ONE 90 (PREVIOUSLY WATERS TECHNOLOGY PARK )  
PA 18-013 MODIFICATION SUBMITTAL :  
ISSUE DATE: 10-13-20

PA MODIFICATION - INTENT AND DESCRIPTION:  
To review and approve architectural building related design modifications made during plan check for code compliance and constructibility.

PA MODIFICATION COBALT- BLOCKS REVISIONS SUMMARY

PA MODIFICATION - INDIGO ROWS REVISIONS SUMMARY

SECOND LEVEL PLAN

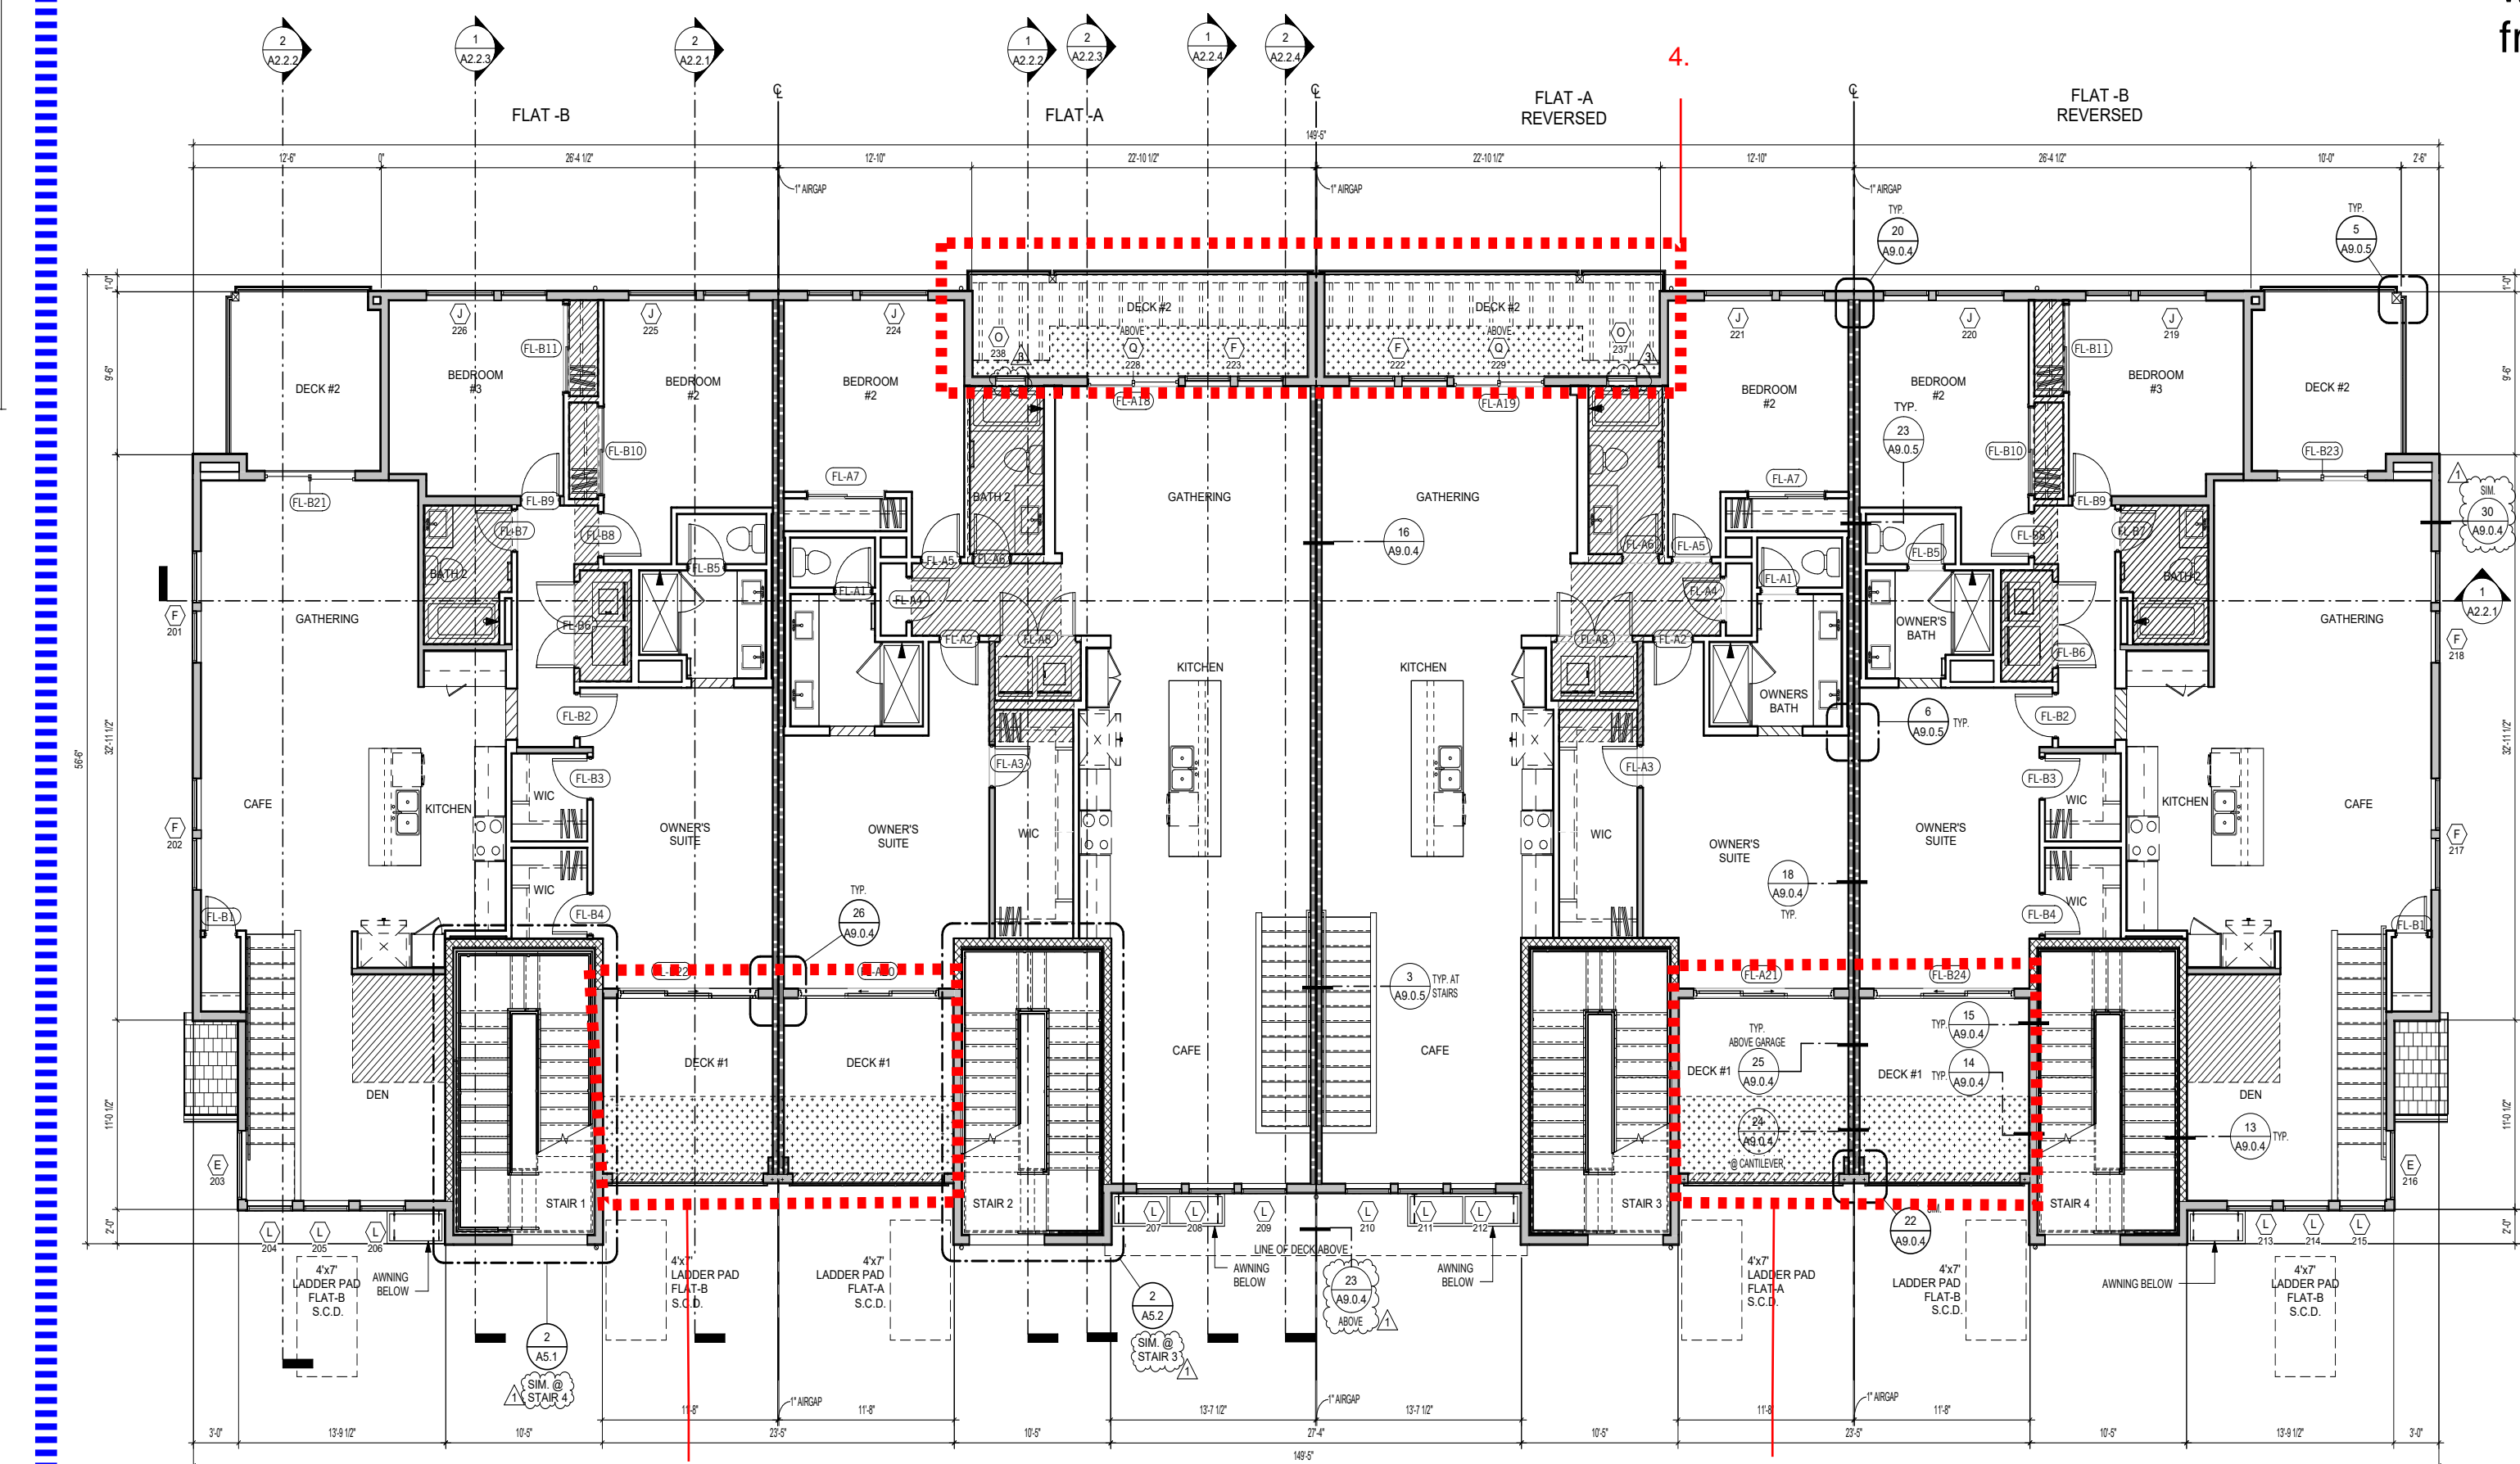
1. All common stairs within each building have been revised from enclosed stairs to covered open stairs to meet exiting requirement for TH units located on third floor. This revision allows stairs to be connected via egress balcony at third floor. The open stair required stair footprint to increase in depth by 1'-0".
2. Added framed structural wall to support balcony/decks on upper levels
3. Revised all patio/balcony unit doors from swing door to sliding door to maximize space in balcony and within the unit. Deck/balcony was extended to align with the egress balcony above. This does not impact the planning area calcs.
4. Revised metal trellis to structural weather treated wood and composite framing members.
